## Contract Change Order # 1

Project Name: <u>Fairway Park Detention - Regional Detention Phase II</u>	Project Number: <u>SW0910B</u>
Project Location: <u>61st Street between Lynn Lane and County Line</u>	Date of Application: <u>Tuesday, July 26, 2016</u>
Contractor: <u>Lowry Construction Services, Inc.</u>	Submitted By: <u>Lowry Hutton</u>

# Change Directive

Contract No. SW0910B  
Field Work Order No. 002  
Project Number SW0910B  
Project Name Fairway Park Detention Phase II  
Project Location North side of 61st between 9th St. and 23rd St.

Figure 6. Typical riprap-lined channel cross-sections. (Source: Ref. 1)

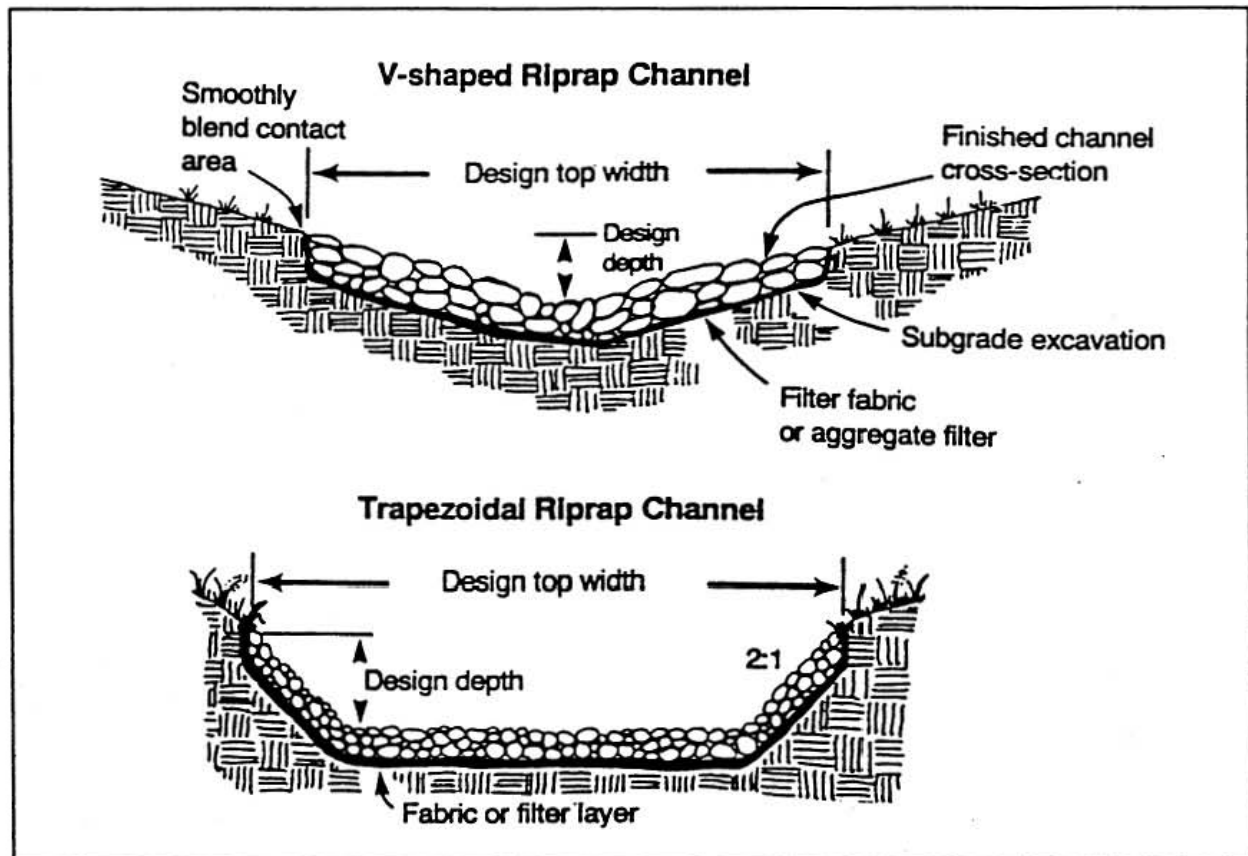
Please provide dimensional cross-section for the Grouted Riprap details shown on Sheet 5 of 5.

The remaining 1,850 SY of grouted rip-rap shall be 12" thickness, without filter blanket, using ODOT spec. 713.02 a3, stone for grouted rip-rap, Type IV. The toe in depth shall be the depth of the rock, see attached figure below.

Per Pre-construction meeting notes, please provide pricing to replace the 925 SY of grouted rip-rap along the eastern basin with un-grouted rip-rap 18 inches thick per ODOT spec 703.02a, Type 1, with filter blanket - non-woven fabric, ie. US 205NW being an acceptable ODOT fabric. The toe in depth shall be the depth of the rock, see attached figure below. Pricing shall be LS and an itemized cost breakdown shall be included. The existing line item shall be undererran and a reconcile change order shall be processed at conclusion of the project.
